Access Compliance Report

Public Rights-of-Way

(Curb Ramps)

Intersection ID: 54423	Main Street: BLARNEY_RIDGE_DR	Cross Street: KILKENNY_DR	Location:	W
ADA ID: FA45F6377796	Ramp Type: Directional1	Initial Pass/Fail: Pass	Overall Compliance: No	Severity Score: 0.25
Codes/Mitigation Info/Possible Solution		Field Measurements/Component Compliance

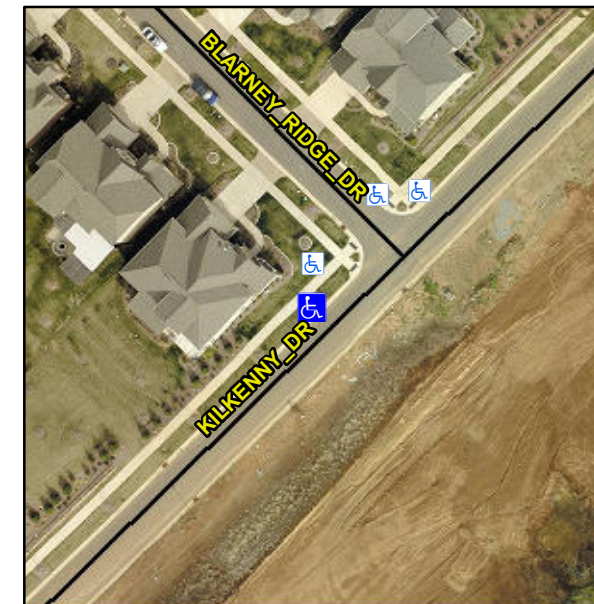
Not Found, R304.5.3, R304.5.2

Compliance	Description	Data	Compliance	Description	Data
N/A	Ramp Length (in)	79.0	No	Grade Break?	No
Yes	Ramp Width (in)	60.5	N/A	Grade Break Slope (%)	4.3
Yes	Ramp Slope (%)	5.4	N/A	Grade Break XSlope (%)	6.0
Yes	Ramp XSlope (%)	3.6			
N/A	Flare Type LT	N/A	N/A	Flare Type RT	N/A
N/A	Flare Slope LT (%)	7.0	N/A	Flare Slope RT (%)	2.1
N/A	Flare Traversable LT?	No	N/A	Flare Traversable RT?	No
Yes	Landing Length (in)	61.0	Yes	DWS Provided?	Yes
Yes	Landing Width (in)	60.5	Yes	DWS Contrast?	Yes
Yes	Landing Slope (%)	1.8	Yes	DWS Length (in)	24.0
No	Landing X Slope (%)	2.9	Yes	DWS Full Width?	Yes
N/A	Landing Curb? (Y/N)	N/A	Yes	DWS Offset LT (in)	13.0
N/A	Shared Landing?	Yes	Yes	DWS Offset RT (in)	0.0
Yes	Gutter Ponding?	No	Yes	Gutter Slope (%)	0.7
Yes	Gutter Lip Ht (in)	0.0	Yes	Gutter X Slope (%)	3.4
N/A	Painted X Walk1?	No		Road Slope (%)	1.2
	X Walk 1 Direction	To SE		Road X Slope (%)	3.9
	X Walk 1 Width (in)	N/A		Clear Space?	Yes

Remove & Replace Entire Ramp.
